Economic and Social Council

Proposal for a technical report on the development of Amendment 5 to UN GTR No. 2 (Measurement procedure for two- and three-wheeled vehicles equipped with a positive or compression ignition engine with regard to the emissions of gaseous pollutants, CO₂ emissions and fuel consumption)

Technical report on the development of Amendment 5 to UN GTR No. 2 on the measurement procedure for two- and three-wheeled vehicles equipped with a positive or compression ignition engine with regard to the emissions of gaseous pollutants, CO₂ emissions and fuel consumption

Figure A1/7

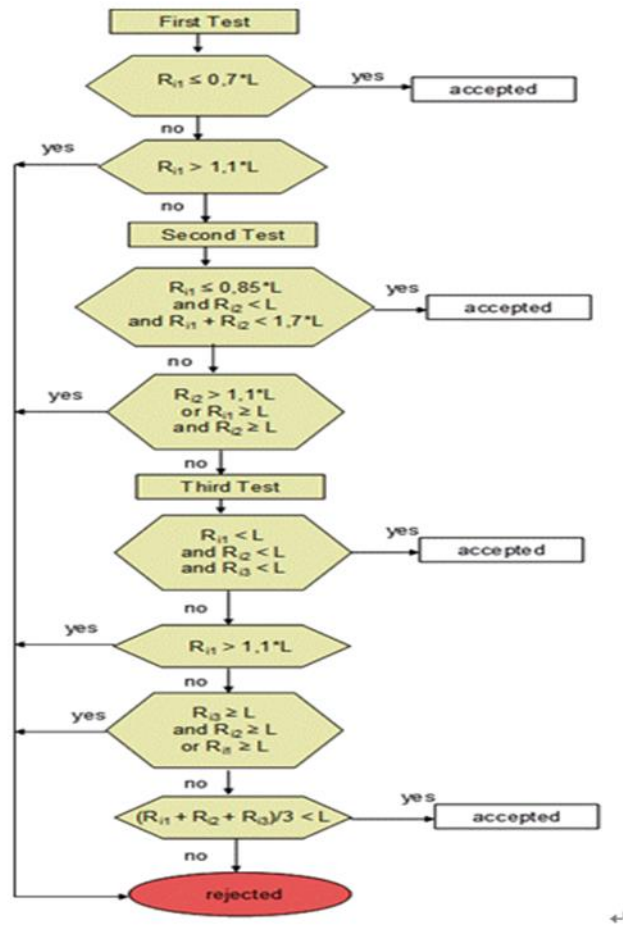
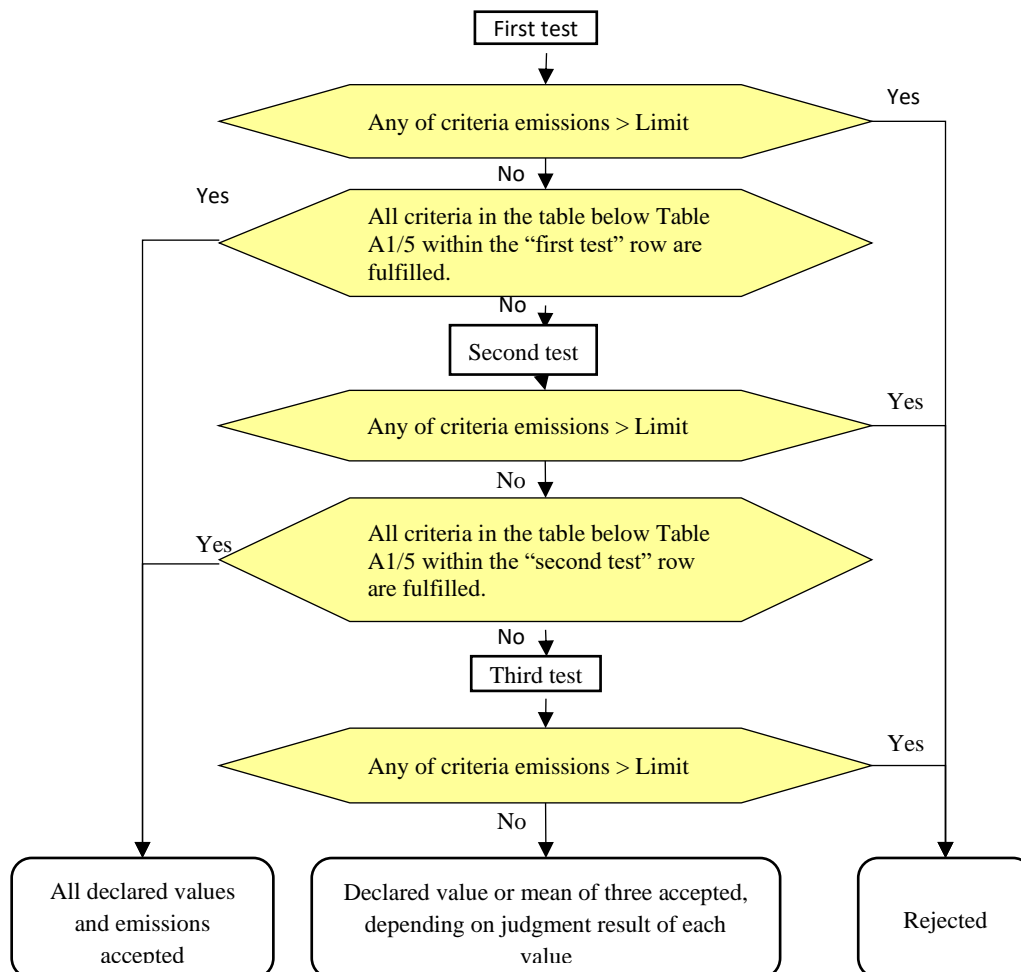
30. In EPPR-43-05 (March 2021), IMMA proposed to substitute the flowchart Figure A1/7 in Amendment 4 with the flowchart Figure A6/1 from the UN GTR No. 15 on WLTP (ECE/TRANS/WP29/2020/127), in order to align it with WLTP.

31. The main difference with the previous flowchart was the correction of the references: from table A5/1 to A6/2.

India/ Kumbhar observed that “declared value or mean of three” was meant for CO₂ and pollutant emissions in UN GTR No. 15, but that this interpretation was not applicable to UN GTR No. 2, not addressing CO₂.

In EPPR-47 (July 2021), The secretariat of the IWG on EPPR invited the IWG to express position on the flowchart Fig. A1/7 in EPPR-46-06, notably on the need or not to have the third test for pollutant emissions.

China had requested at last EPPR-46 session whether the third test was needed for pollutant emissions.

In lack of counter-proposals, the flowchart in EPPR-46-06 remained as in Figure A1/7, noting that the third test applied only to pollutant emissions in UN GTR No. 2.
